Lake Merritt Station Area Plan

Final Environmental Impact Report

July 2014

Prepared for the **City of Oakland** by

**Figure 2.4-2
Existing Zoning Districts**

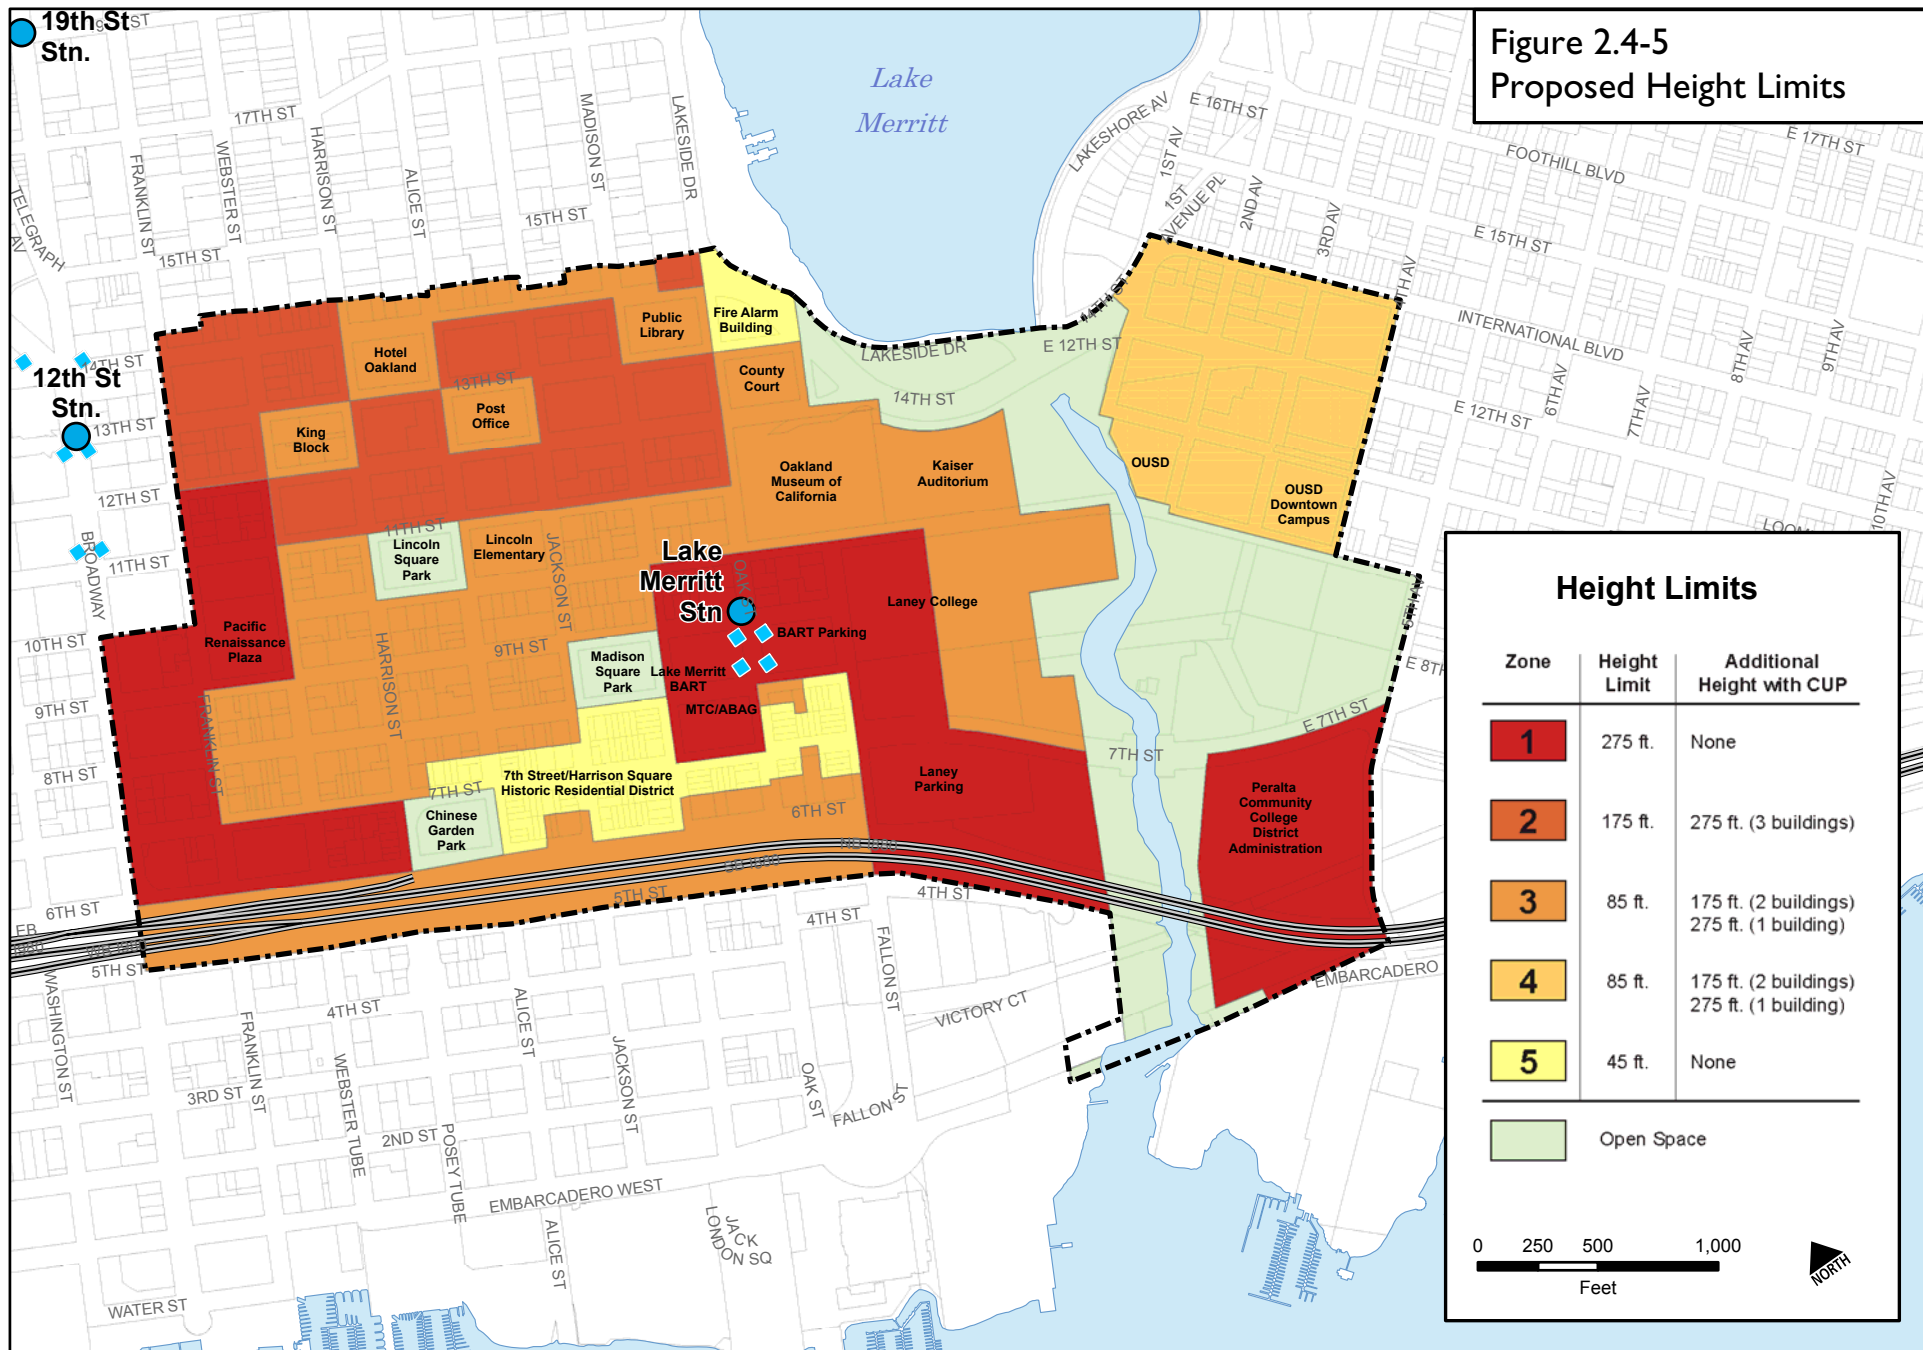
Figure 2.4-2: Existing Zoning Districts is revised to remove Chinese street names and opportunity sites.

- Figure 2.4-1: General Plan and Estuary Policy Plan Amendments is revised to clean up formatting by removing the opportunity sites from the map.
- Figure 2.4-2: Existing Zoning Districts is revised to clean up formatting by removing Chinese street names and opportunity sites.

Fig. 3.8-1
Historic Resources

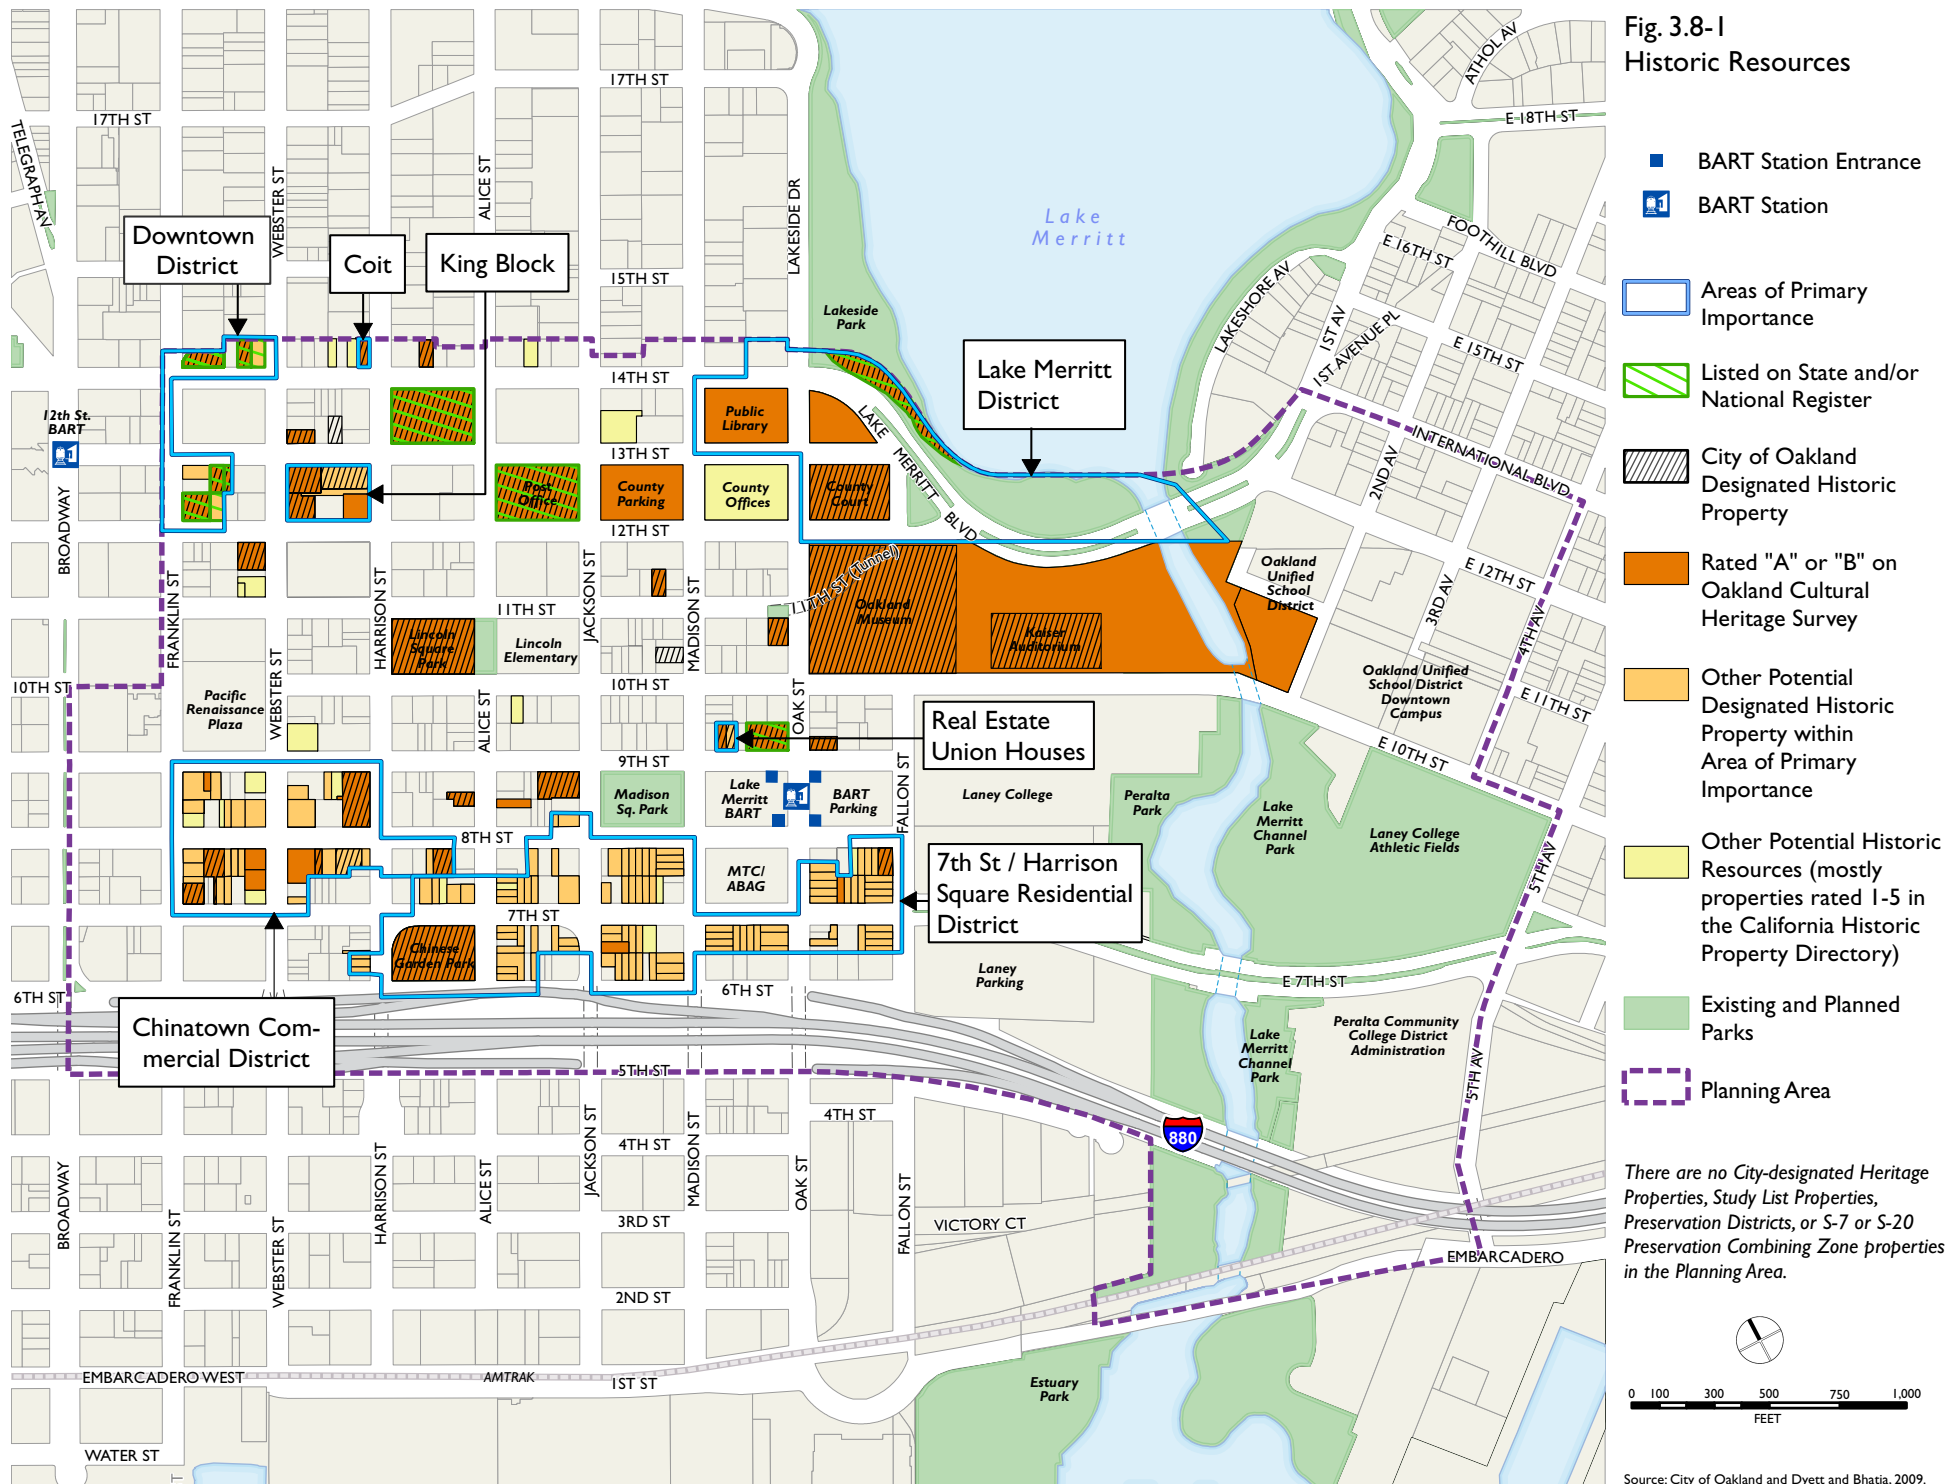
Figure 3.8-1 Historic Resources is revised, using a more distinct symbology for sites listed on the State and/or National Register.

- C1-6: Figure 3.8-1: Historic Resources and Figure 3.8-2: Historic Resources & Opportunity Sites are updated, using a different symbol to denote State and/or National Register-listed properties.

Fig. 3.8-2
Historic Resources &
Opportunity Sites

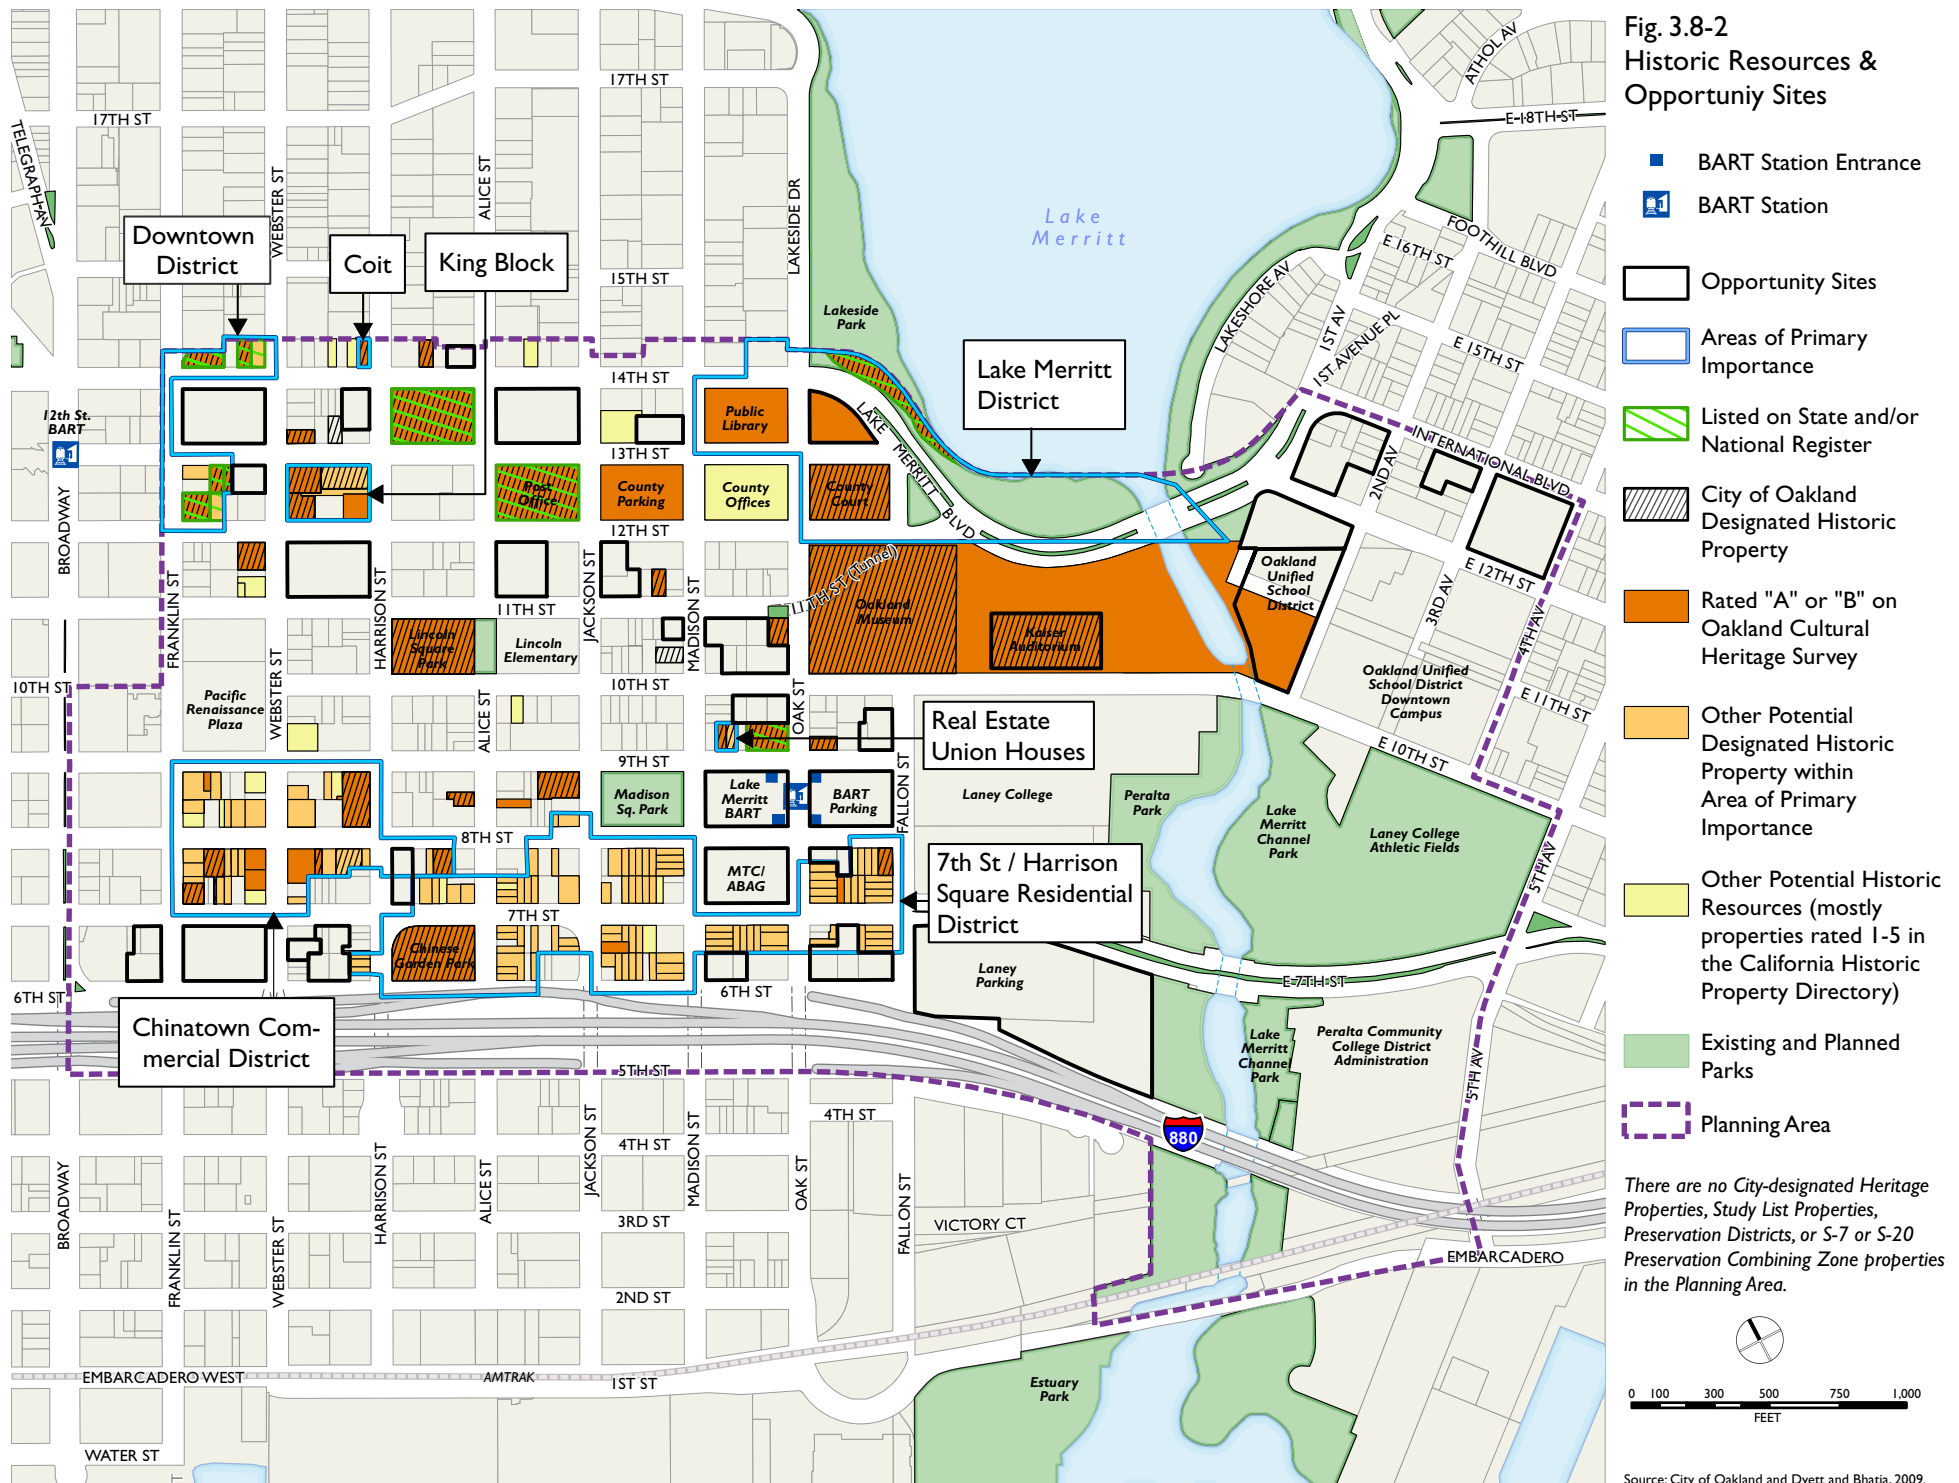
Figure 3.8-2 Historic Resources & Opportunity Sites is revised, using a more distinct symbology for sites listed on the State and/or National Register, and to identify Fire Alarm Building site.

Figure 3.8-3
Height Areas and Historic
Areas of Primary
Importance

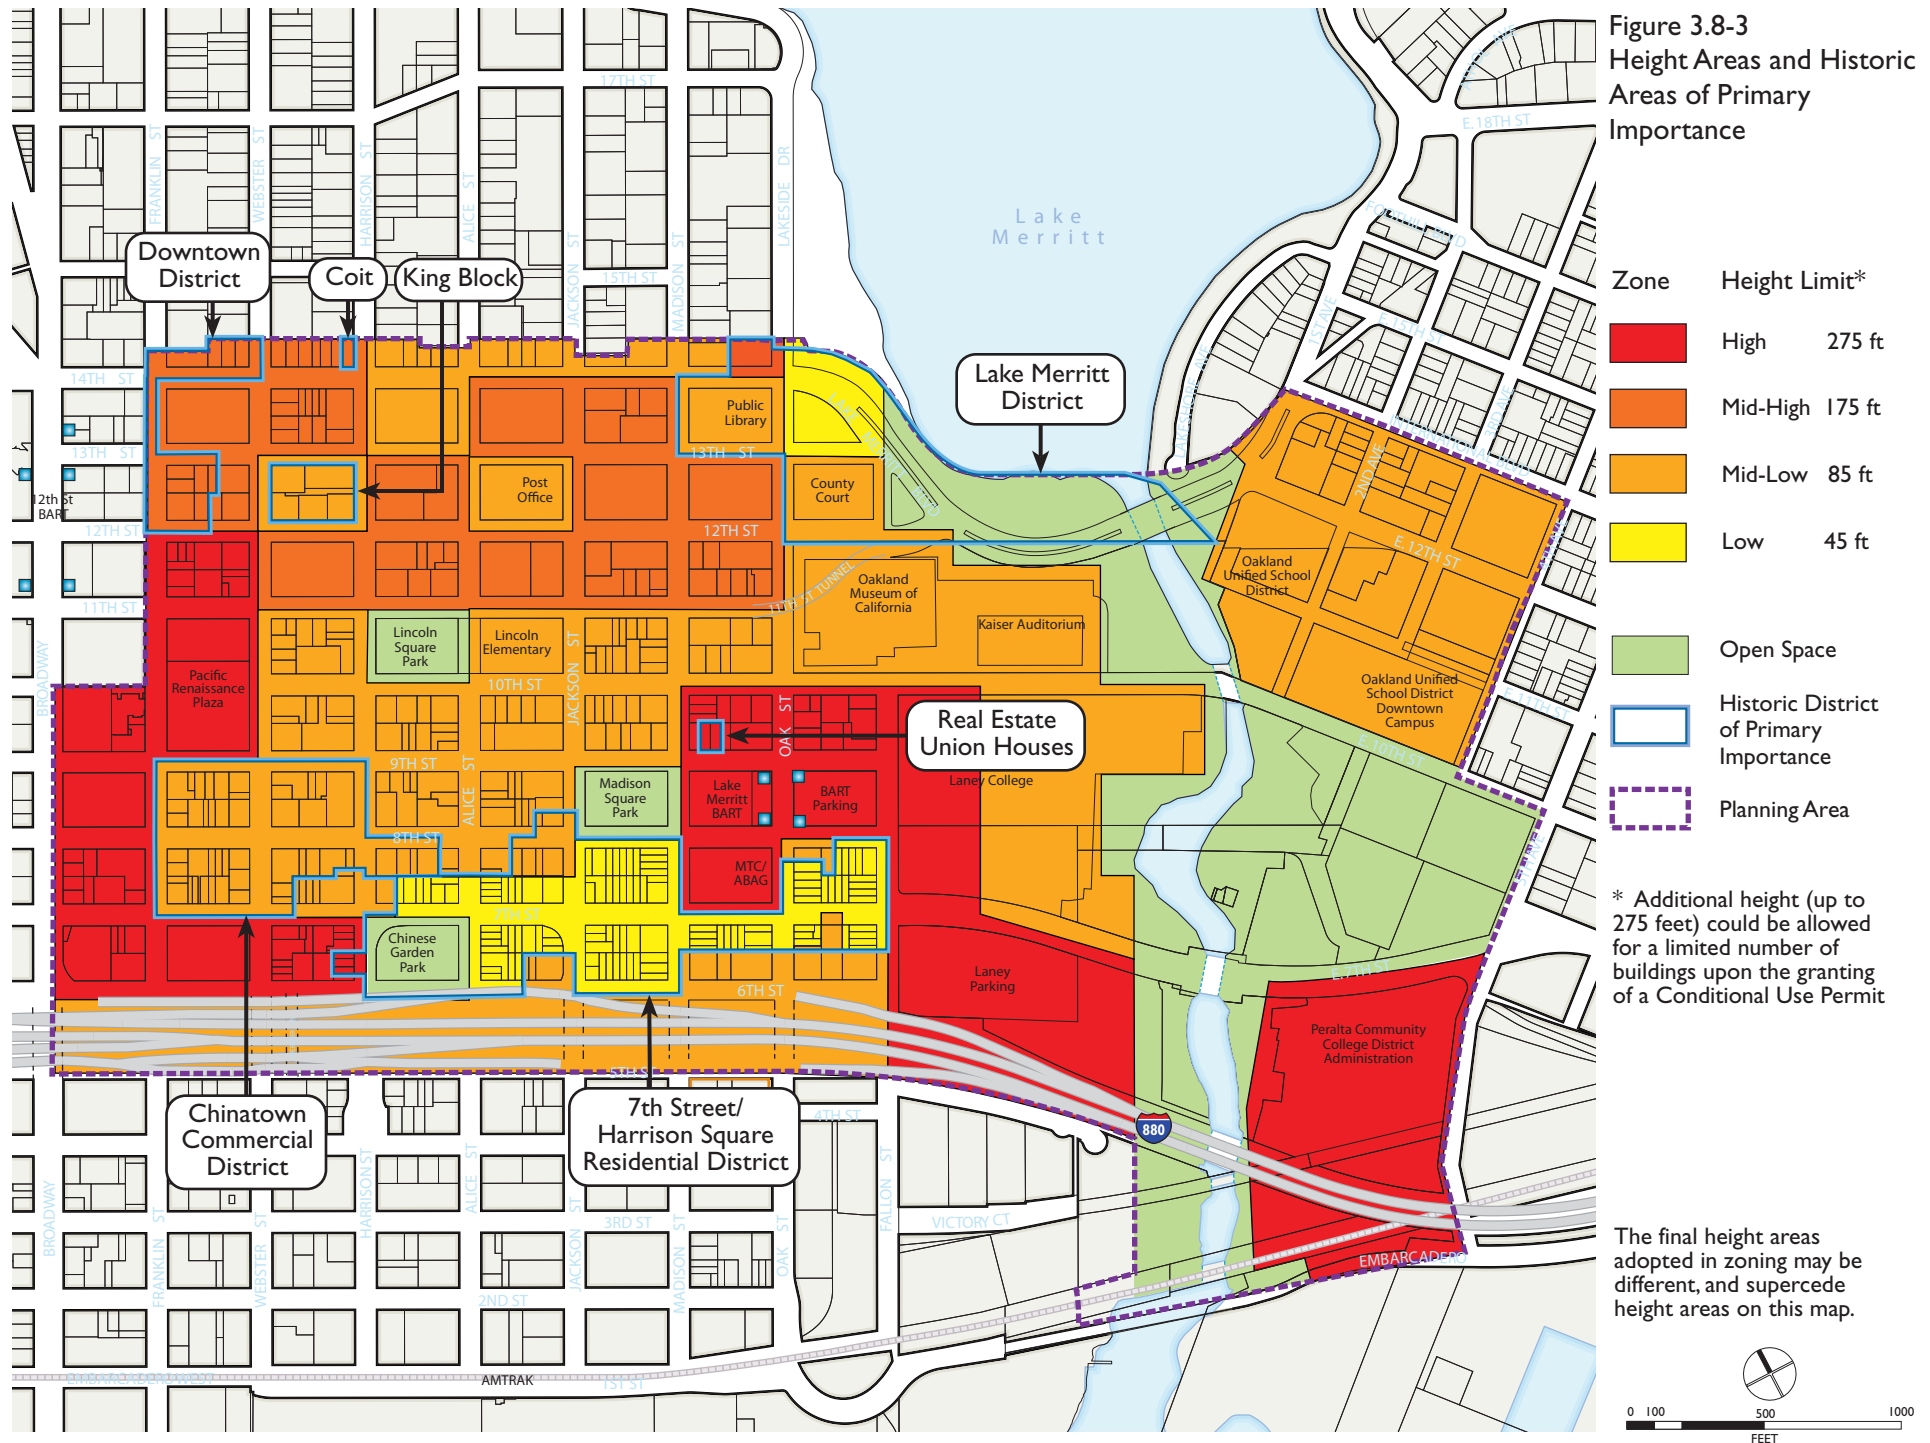
Figure 3.8-3: Height Areas and Historic Areas of Primary Importance is revised to reflect the Plan changes to Height Areas described in Chapter 2 of this FEIR.
